REPORT FOR ACTION

Traffic Calming (Speed Humps) - Lonsdale Road

Date: January 12, 2018

Wards: Ward 21, St. Paul's

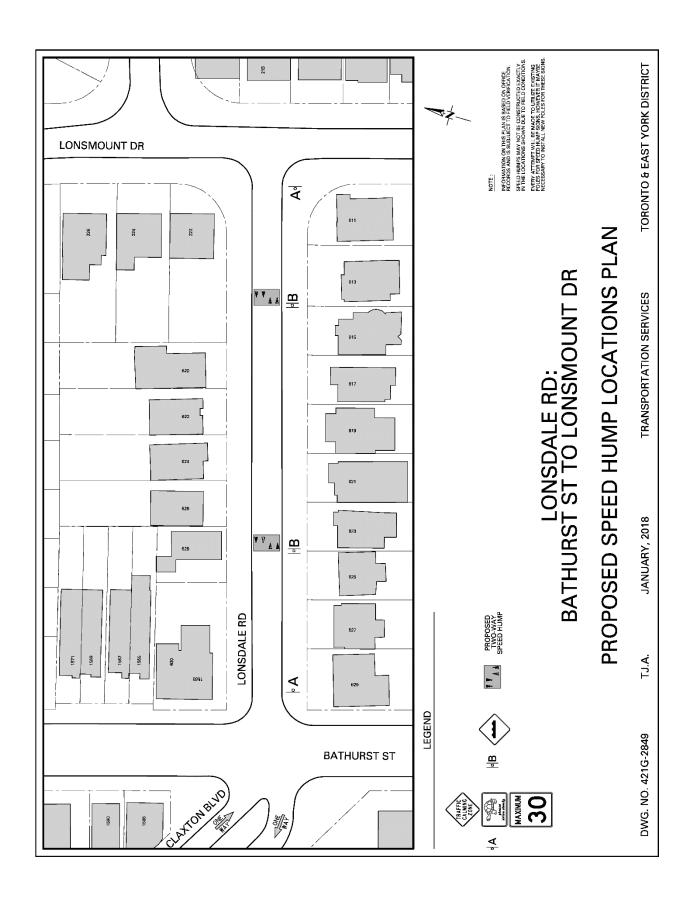
I have received and reviewed the proposal for installation of speed humps on Lonsdale Road, between Bathurst Street and Lonsmount Drive. I have the following comments:

As documented in the Traffic Calming Policy, Toronto Paramedic Services has concerns regarding the usage of traffic calming measures, specifically vertical obstacle measures such as speed humps. These have a negative impact on emergency call response times, travel times to hospital and on patient comfort during transport. This delay is cumulative with each obstacle and can directly impact patient outcome.

In addition to concern for patient outcome and safety it is noted that this proposal does not meet the Warrant Criteria as set out in the Policy. Therefore, Toronto Paramedic Services is opposed to the installation of traffic calming devices on Lonsdale Road, between Bathurst Street and Lonsmount Drive. It is important that the applicant fully understands the potential for delay in emergency response and that alternatives to vertical measures be considered and evaluated.

Fire Services does not support this proposed speed hump installation as it may slow our responding vehicles and affect delivery of service in the quickest possible manner. Increased time can impact the effectiveness of the services provided during any emergency. The vertical restrictions imposed by a speed hump have a much greater impact on larger fire vehicles than smaller passenger vehicles. Response time increase with every obstacle a fire vehicle encounters on route to any emergency incident. Although the increase at each hump may only be seconds, the cumulative effect can be a significant amount of time.

Fire Services recommends that non-physical measures (lower speed limits or prohibited turns) be implemented and evaluated before physical forms are considered. Desired results may be obtainable without imposing a physical obstruction to emergency vehicles.
